Product Change Notification

Product Group: TC/Wednesday April 15, 2026/PCN-TC-014-2024-REV-1

Introduction of Compression Seal GTMS in HE3/HE5 Families

Visual comparison of parts before and after the change	
Standard GTMS (before the change)	GTMS with compression seal (after the change)

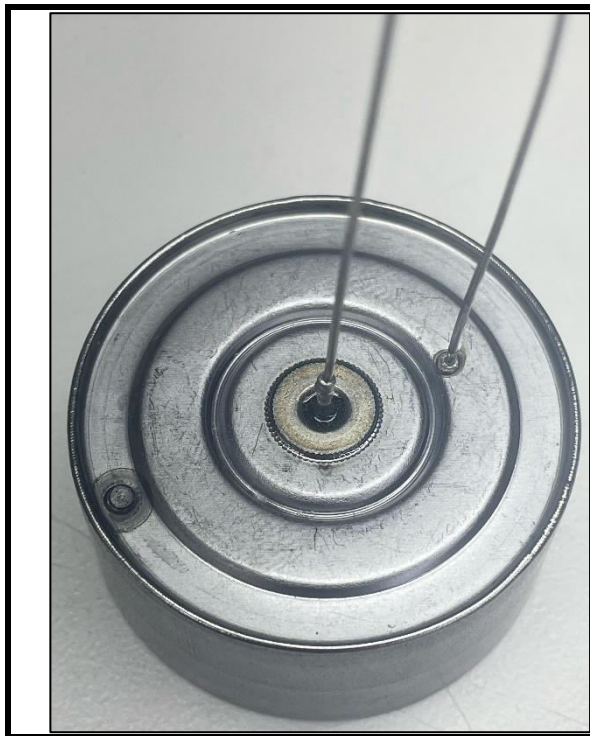
Description of Change: Glass To Metal Seal (GTMS) design change.

Reason for Change: To enhance product reliability and streamline manufacturing processes, Vishay is introducing a compression seal GTMS design for the HE3 and HE5 families, including DLA 10011 series. This change aligns with our commitment to continuous improvement and customer satisfaction.

Expected Influence on Quality/Reliability/Performance: Aside from an external appearance of the product, which will be slight, the performance of the product and its reliability will remain unaffected.
